**Subject: Docket Nos. 50-361 and 50-362
Proposed Technical Specification Change Number NPF-10/15-516
Reduce the Minimum Boltup Temperature for Reactor Vessel Head
Bolts When They Are Tensioned
San Onofre Nuclear Generating Station Units 2 and 3**

AMENDMENT APPLICATIONS 199 AND 184

(PCN-516)

**DESCRIPTION AND SAFETY ANALYSIS
OF PROPOSED CHANGES NPF-10-516 and NPF-15-516**

Figure 3.4.3-1

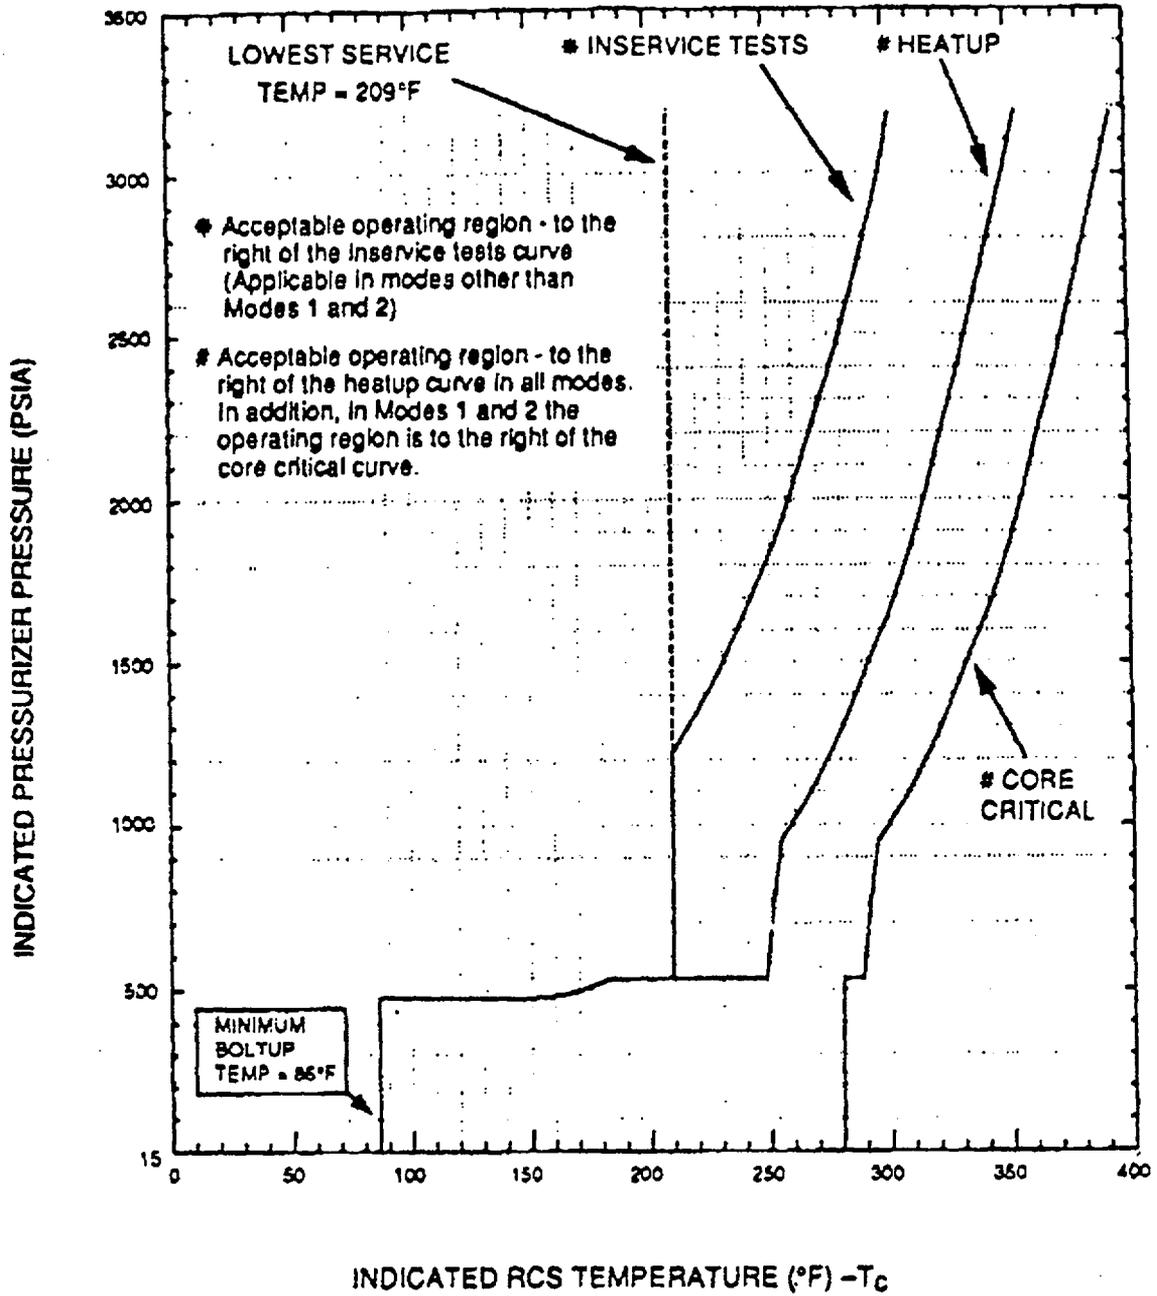
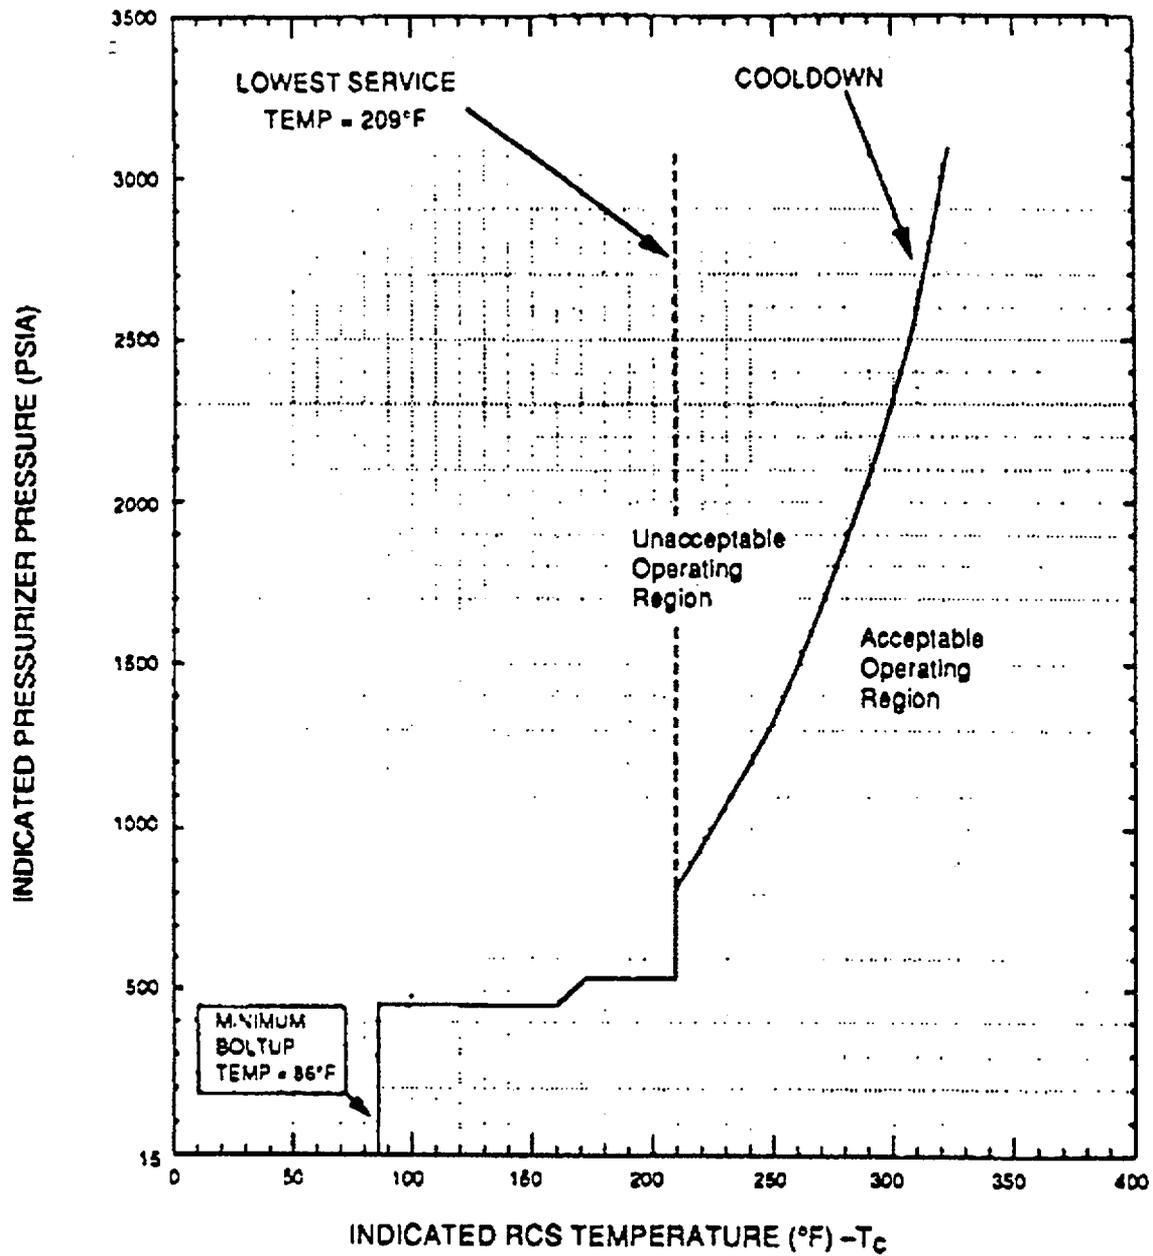
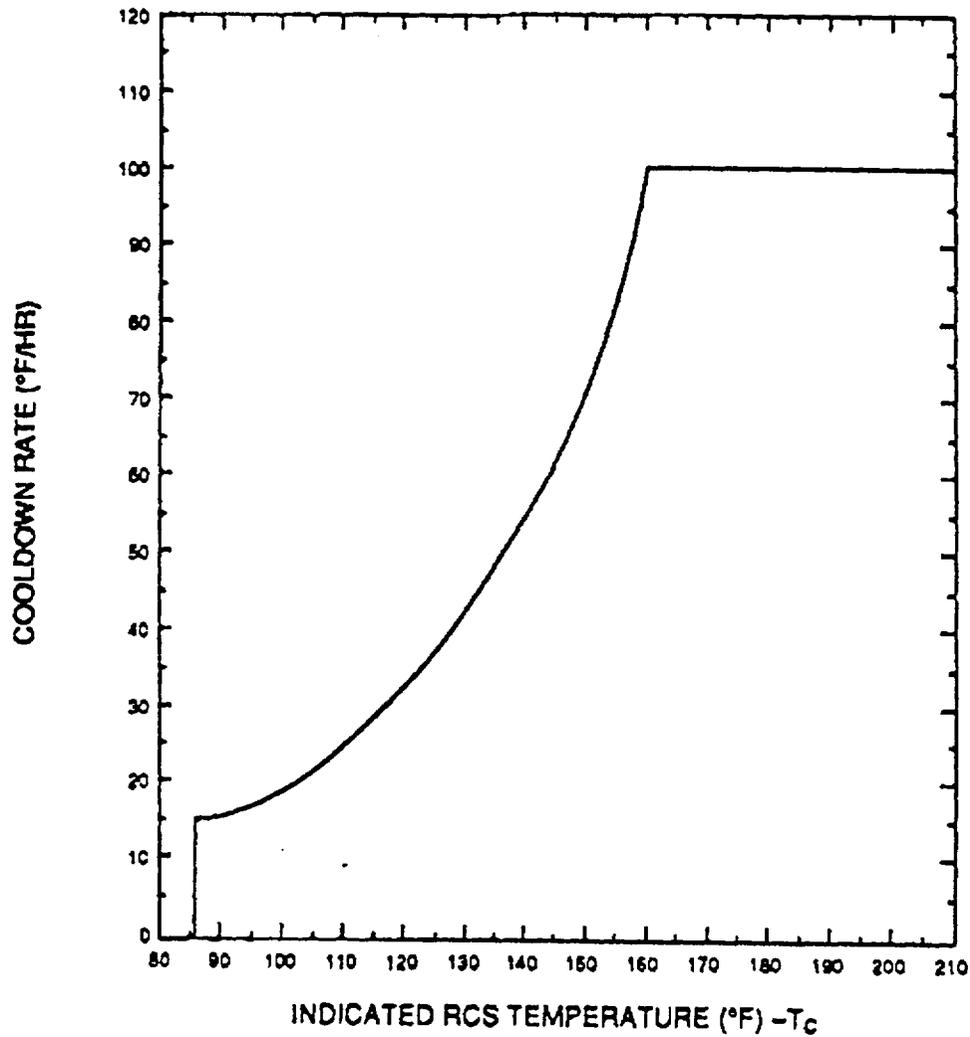
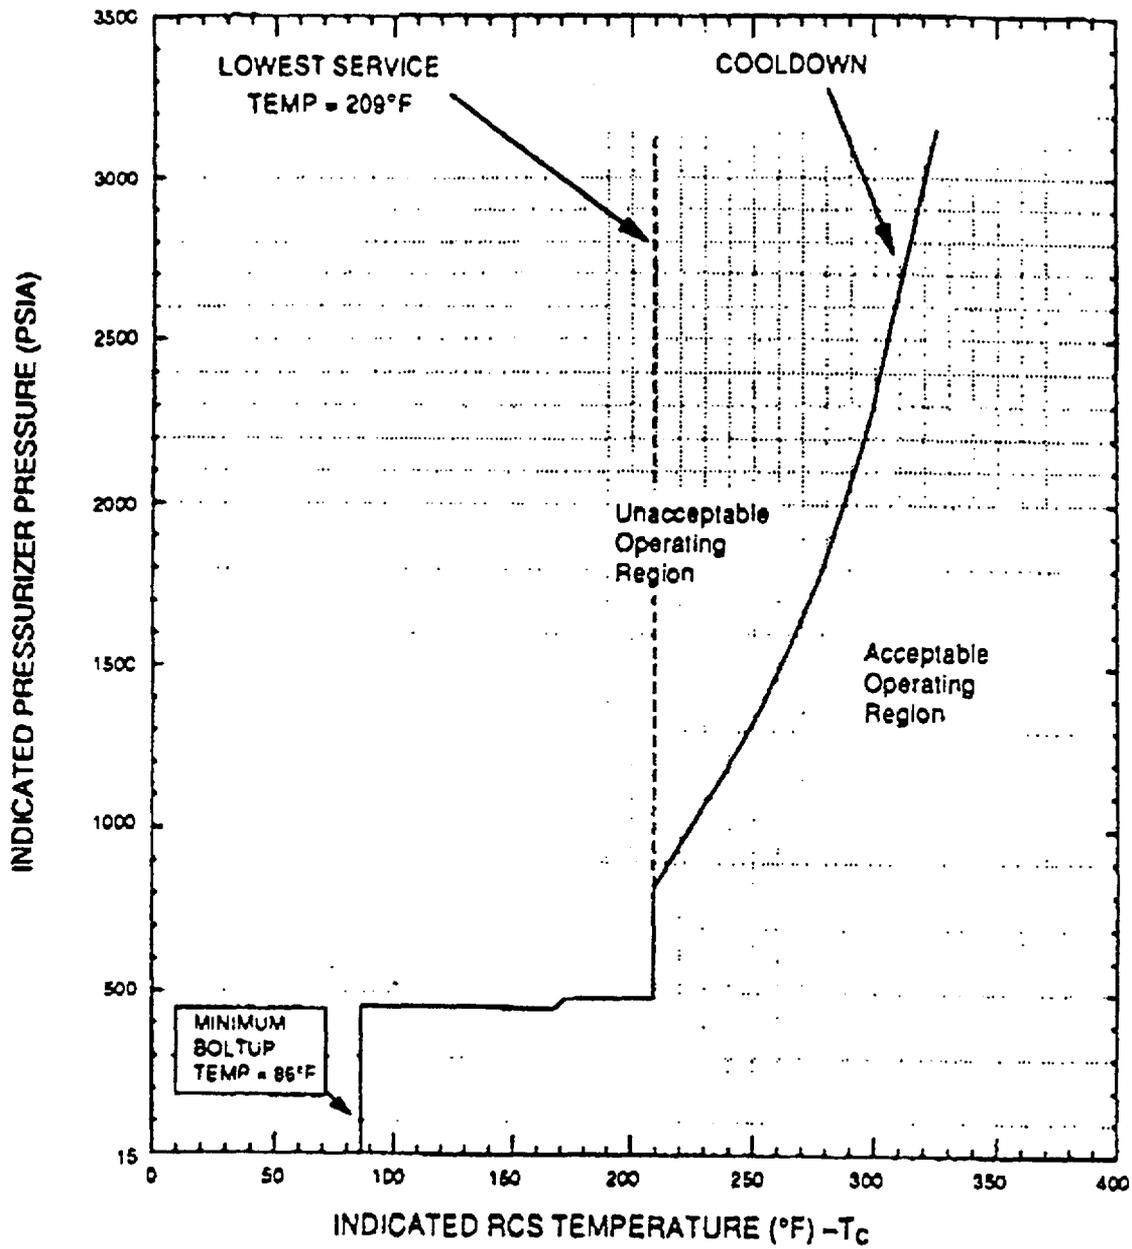
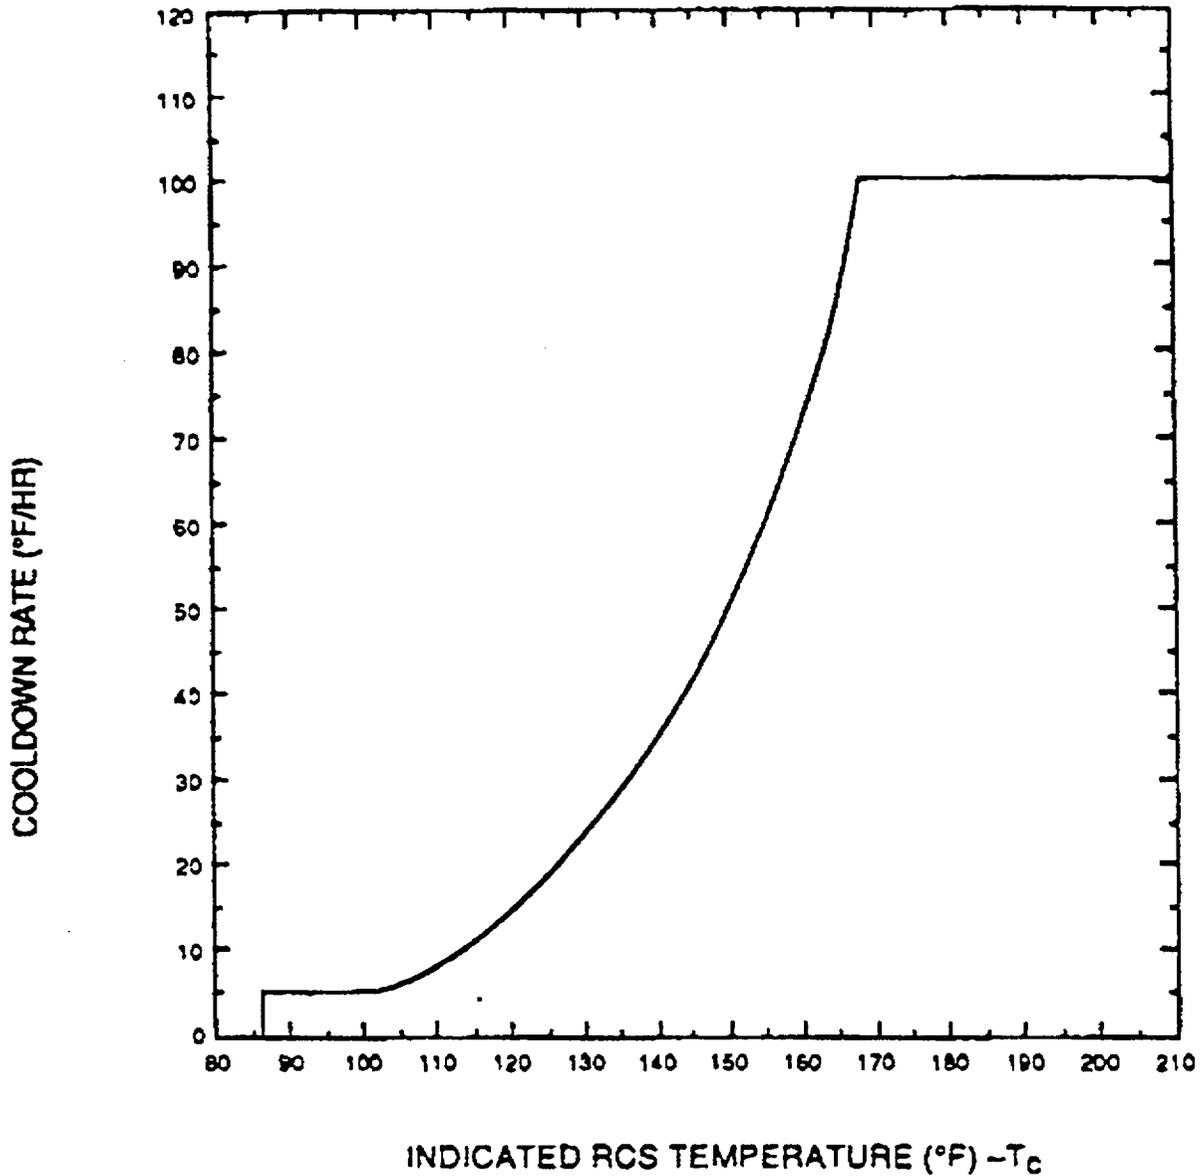
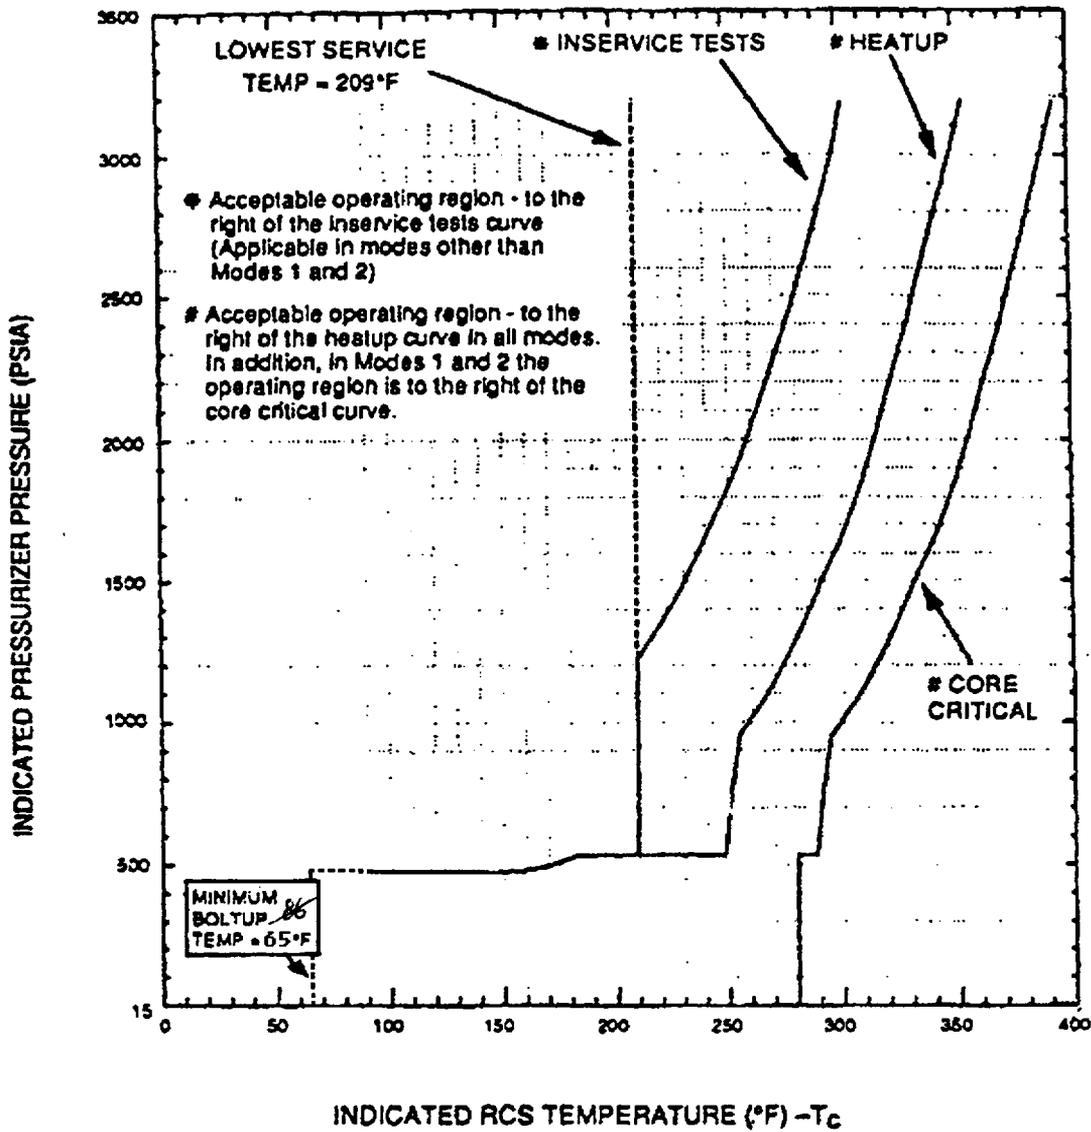
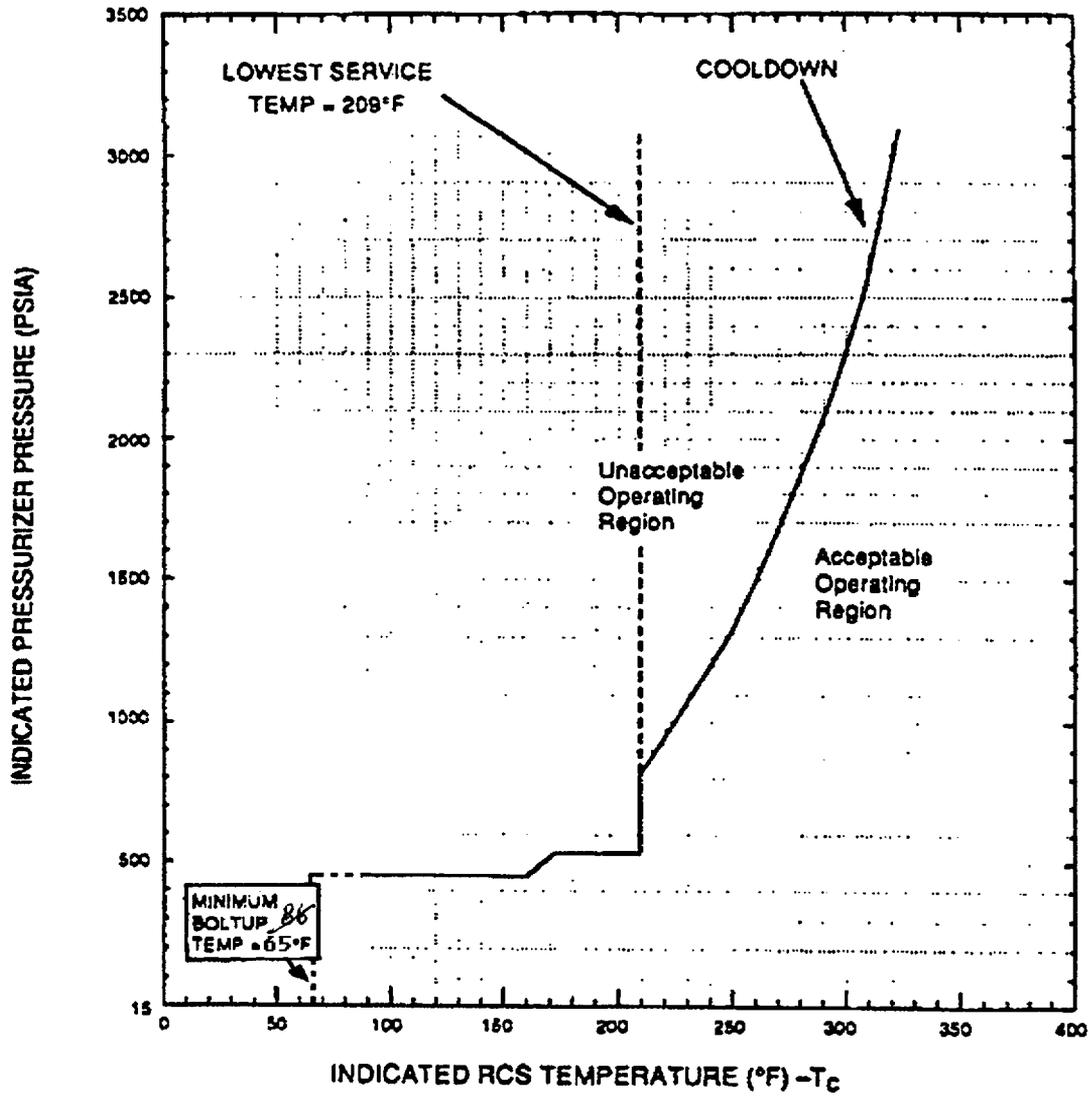
LCO Conditions "a" and "d", a footnote at page 3.4-5 and Figures 3.4.3-1 through 3.4.3-5 will be revised to reflect this new value. The Pressure-Temperature curves on Figures 3.4.3-1 through 3.4.3-5 will be extended from 86°F to 65°F. During operation at temperatures between 86°F and 65°F, the pressure limit change is negligible. Additionally, the TS bases will be updated to reflect the basis for the MBT of 65°F.
